Product/Process Change Notice (PCN)																																				
<input type="checkbox"/> Major Change <input checked="" type="checkbox"/> Minor Change																																				
PCN Number: PCN_FrqXTAL_20250219 Affected Series: WE-XTAL Affected Part Number: See table below PCN Date: 2024-11-19 (YYYY-MM-DD) Effective Date: 2025-02-19 (YYYY-MM-DD)	Change Category: <input type="checkbox"/> Equipment/Location <input checked="" type="checkbox"/> General Data <input type="checkbox"/> Material <input type="checkbox"/> Process <input type="checkbox"/> Product Design <input type="checkbox"/> Shipping/Packaging <input type="checkbox"/> Supplier <input type="checkbox"/> Software																																			
Contact: Product Management Phone: +49 (0) 7942 - 945 5001 Fax: +49 (0) 7942 - 945 5179 E-Mail: pcn.eisos@we-online.com	Datasheet Change: <input checked="" type="checkbox"/> Yes <input type="checkbox"/> No Attachment: <input type="checkbox"/> Yes <input checked="" type="checkbox"/> No																																			
DESCRIPTION OF CHANGE: <p>Because of a database mismatch, Würth Elektronik eiSos will correct the RoHs status (1), packaging details (2), product dime

3. Correction of the Product Dimensions:

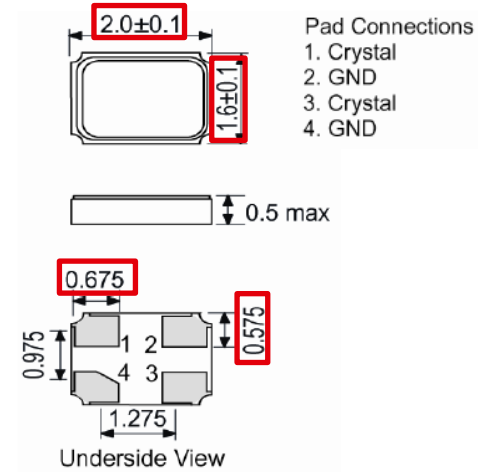
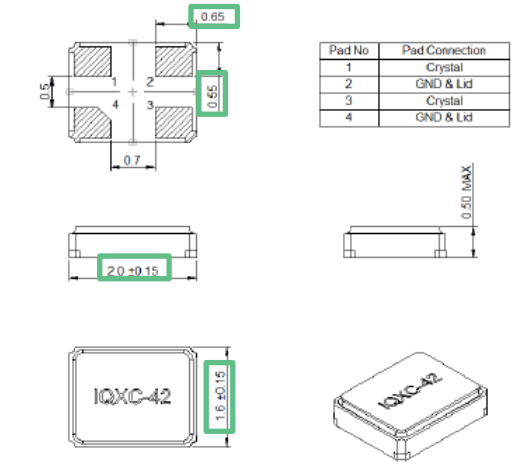
Before	After										
Product Dimensions	 <p>Pad Connections 1. Crystal 2. GND 3. Crystal 4. GND</p>

Pad No	Pad Connection	1	Crystal	2	GND & Lid	3	Crystal	4	GND & Lid
Pad No	Pad Connection											
1	Crystal											
2	GND & Lid											
3	Crystal											
4	GND & Lid											
L	2.0 ± 0.1	2.0 ± 0.15										
W	1.6 ± 0.1	1.6 ± 0.15										
H	0.5 max	0.5 max

4. Correction of the Solder Pad Layout

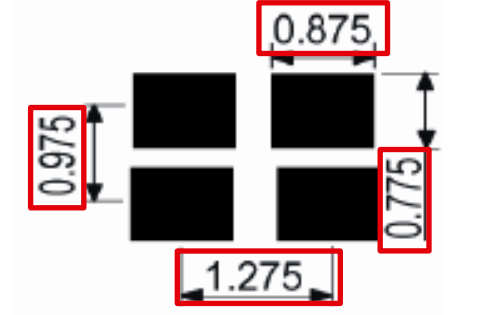
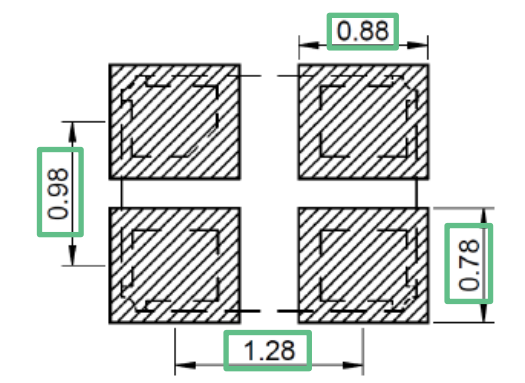
Before	After
Solder Pad Layout
